APPLICATION FOR VARIANCE AND/OR TIME EXTENSION  
HOUSING BOARD OF APPEALS

## STAFF REPORT

Housing Board of Appeals Request **HBA16-014** at 903 DEWEY ST, ANN ARBOR, MI 48104.  
(Parcel Identification Number: 09-09-33-215-009)

Housing Board of Appeals Request **HBA16-014** at 903 DEWEY ST, ANN ARBOR, MI 48104.

# BASEMENT RENOVATION PLAN

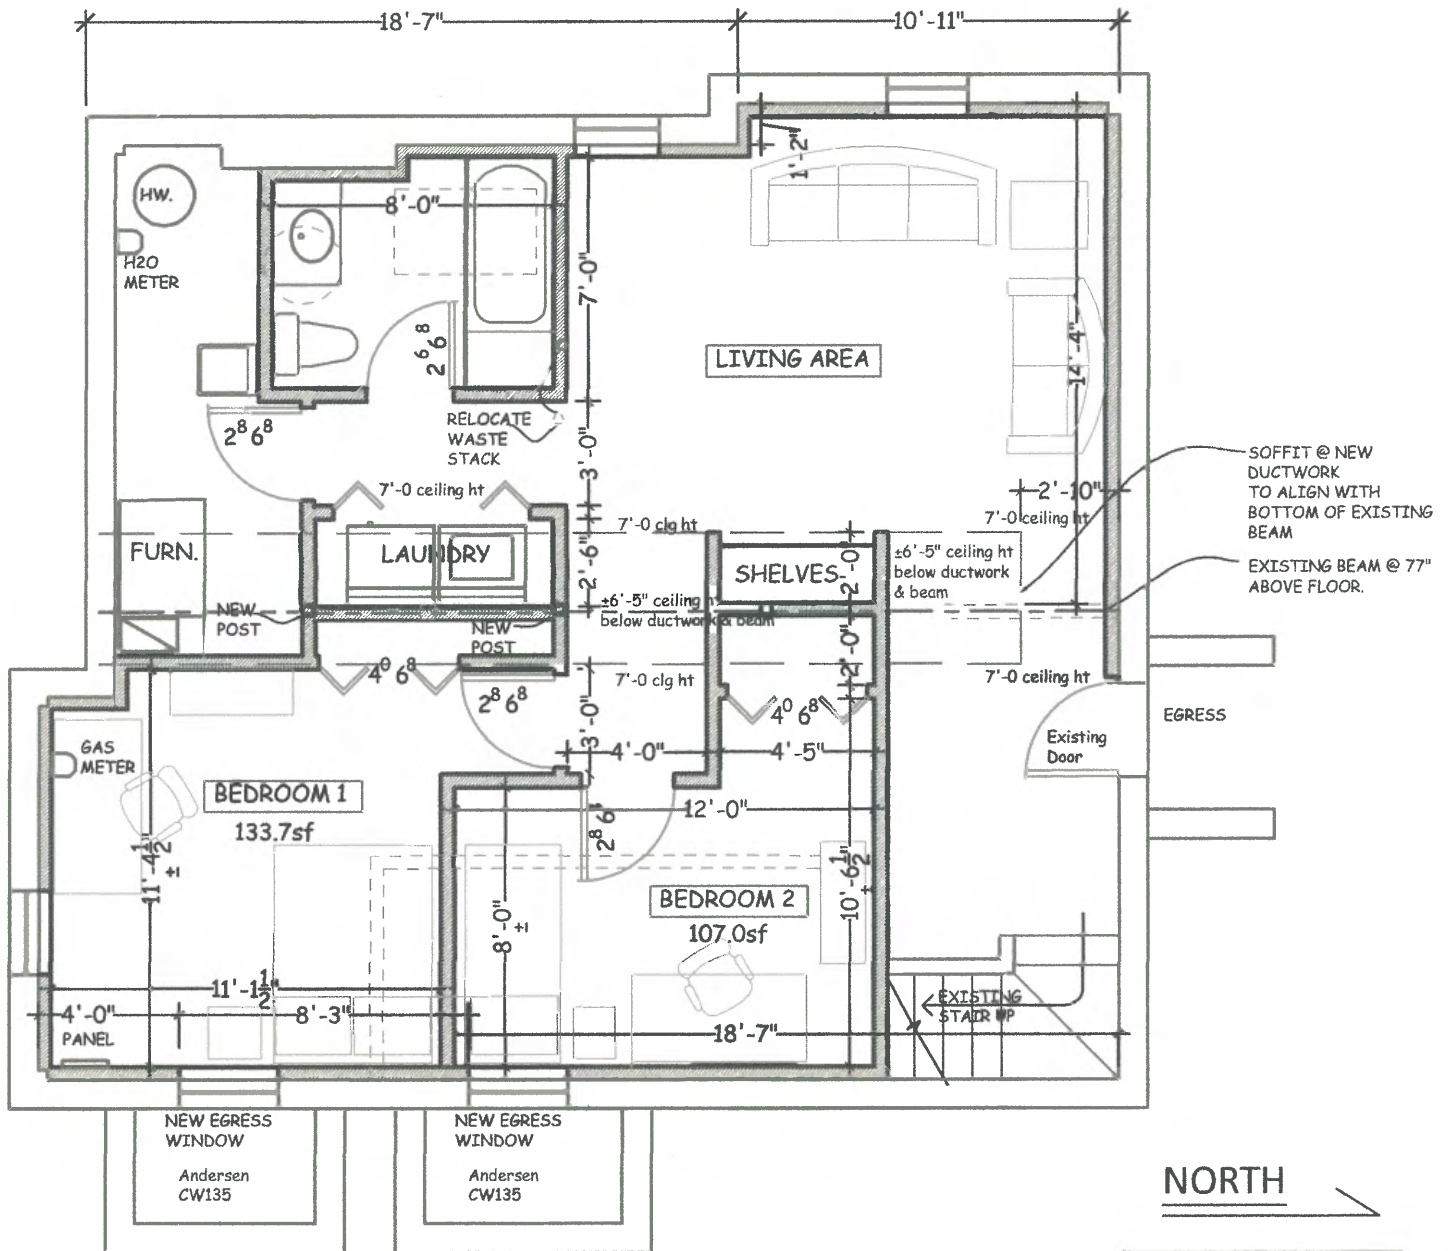
The floor area of Bedroom #1 is 133.7SF. This requires natural light area of 10.7sf and ventilation area of 5.35sf. However only 7.7 sf of natural light area is provided and yet 6.7 sf of ventilation area is provided as the room was build and approved by the Ann Arbor Building Department.

The floor area of Bedroom #2 is 107 SF. This requires natural light of 8.56 sf and ventilation area of 4.28 sf. However only 5.7sf of natural light area is provided and yet 5.7sf of ventilation area is provided as this room also was build and approved by the Ann Arbor Building Department

The proposed work to comply with housing code requirements would include downsizing of both Bedrooms #1 and #2. By increasing the size of the closets, the square footage of the bedroom would be reduced such that the natural light and ventilation requirements would be met.

A variance is requested to keep Bedrooms as they were built and approved even though they are not in current compliance with the Ann Arbor Housing Code (Ann Arbor, Michigan – Code of Ordinances/ TITLE VIII BUILDING REGULATIONS/ Chapter 105 – Housing Code). It seems in order to meet the intent of the ordinance it would be a better solution to keep the rooms (as they were constructed) with a slightly larger size rather reducing them to meet the required percentages of daylight and ventilation required.

### FOOTCANDLE CALCULATIONS FOR LIVING AREA, BEDROOM 1 & BEDROOM 2

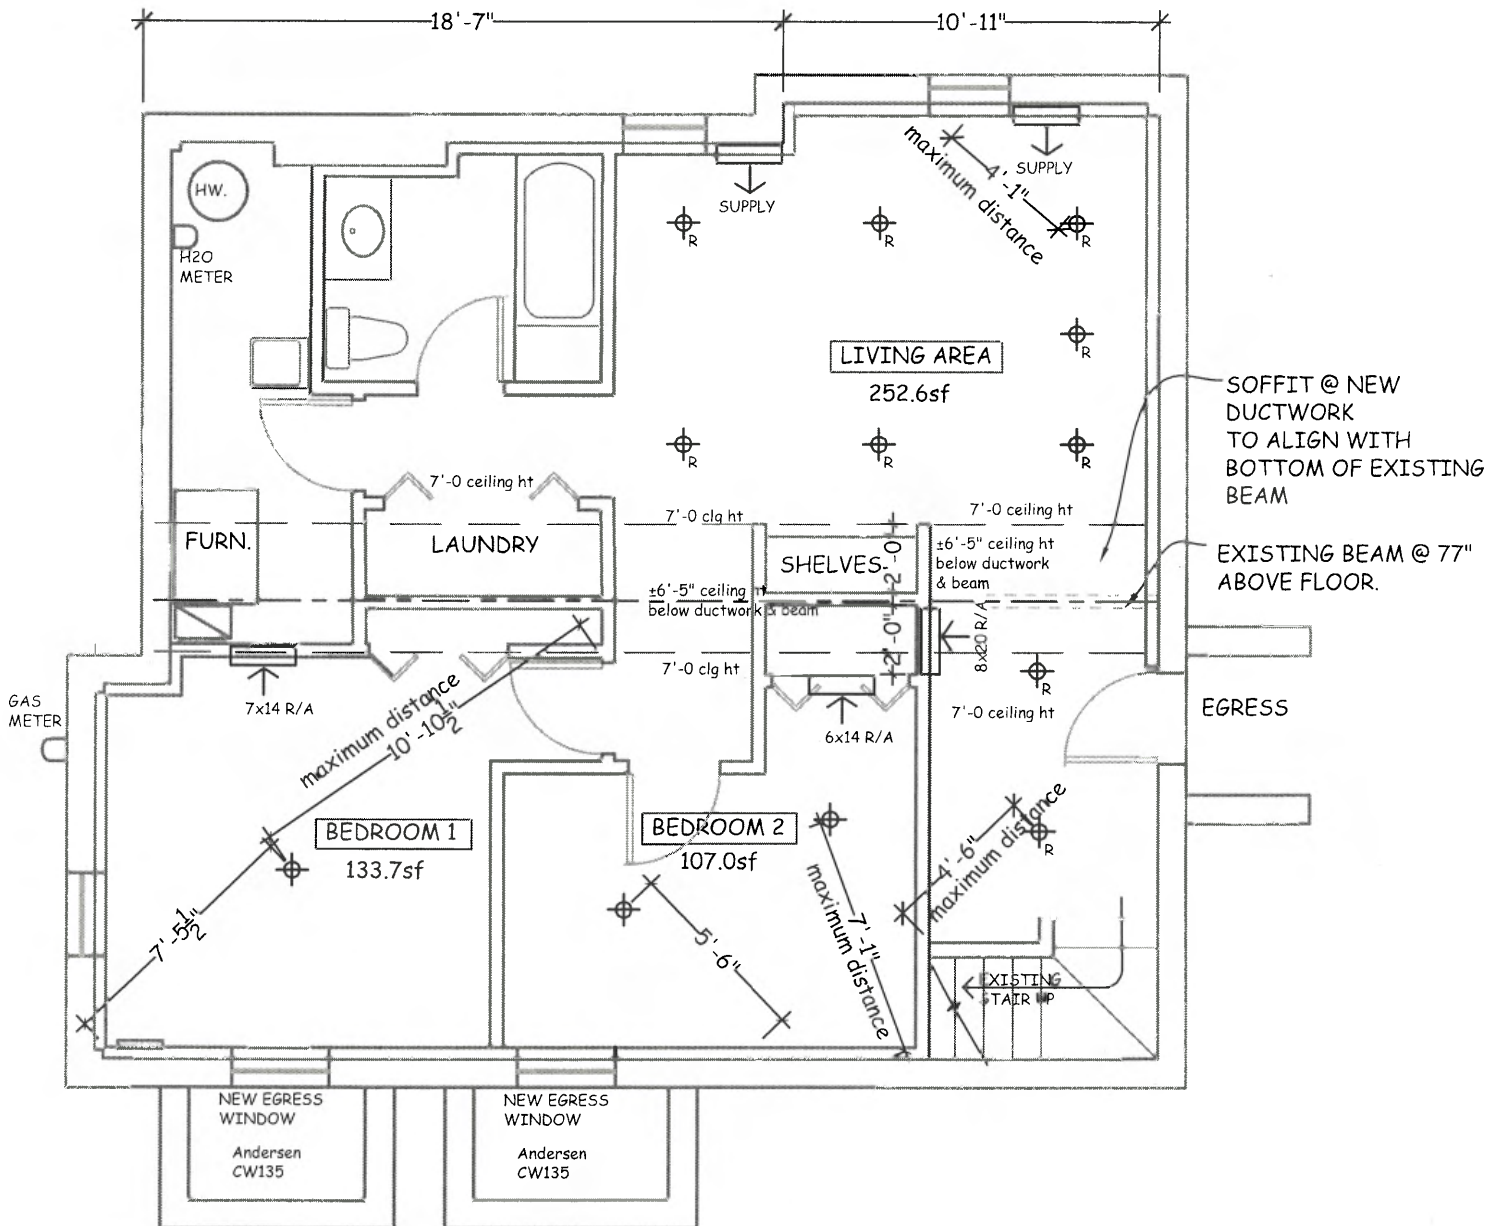
- **LIVING AREA ( Refer to attached Plan and Section)**

- **BED ROOM 1 ( Refer to attached Plan and Section)**

- **BED ROOM 2 ( Refer to attached Plan and Section)**

$$\text{FCh} = (850/6.33^2) * 4.5 = \mathbf{95 \text{ footcandles}}$$

$$\text{FCh} = (1400/11.42^2) * 4.5 = \mathbf{48 \text{ footcandles}}$$

$$\text{FCh} = (1400/8.0^2) * 4.5 = \mathbf{98 \text{ footcandles}}$$

## LIGHTING OUTPUT SECTIONS

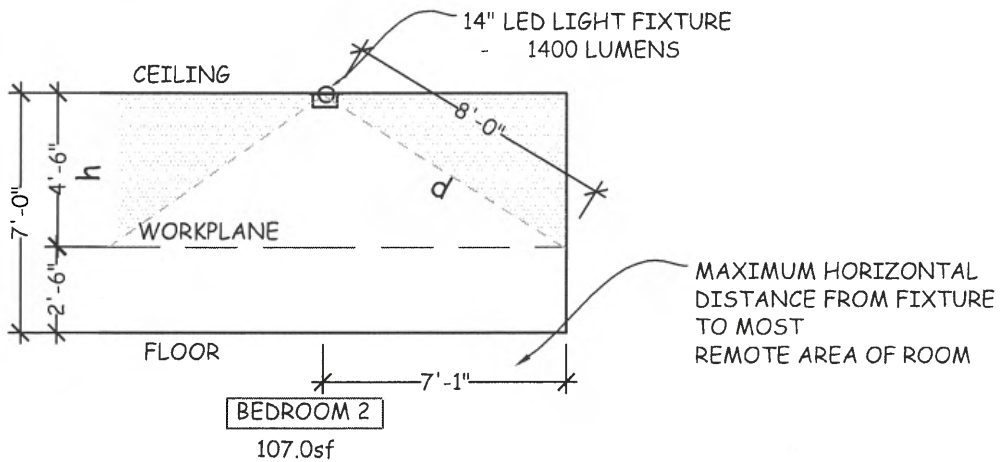
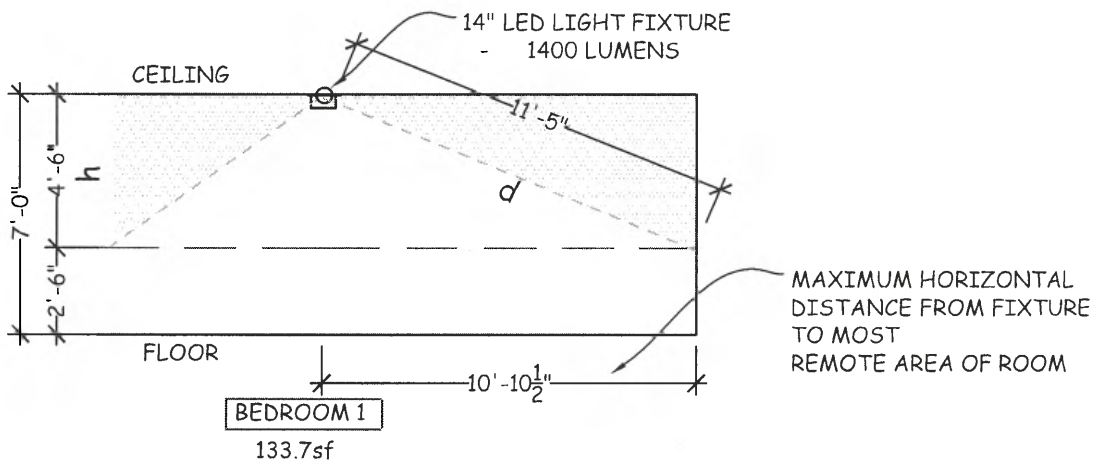
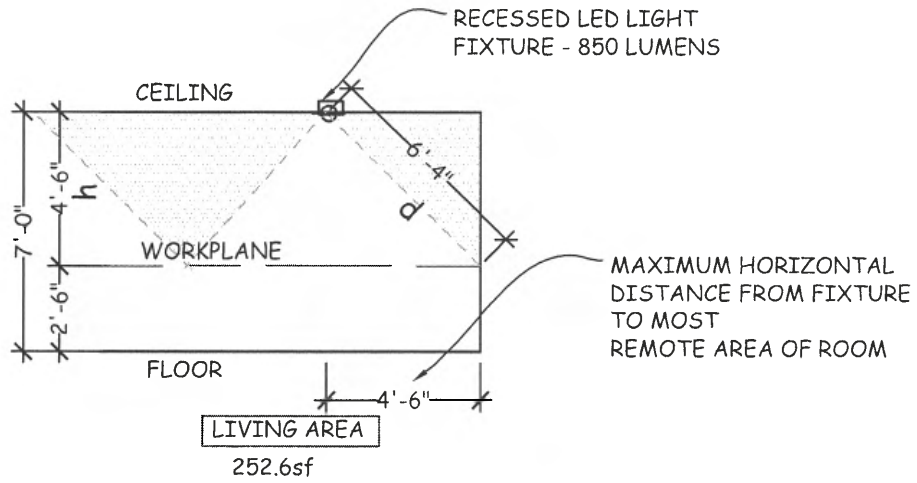
Horizontal Footcandles at a work plane of 30" ( 2'-6") off the floor

Horizontal Footcandles at a work plane of 30" ( 2'-6") off the floor

Horizontal Footcandles at a work plane of 30" ( 2'-6") off the floor
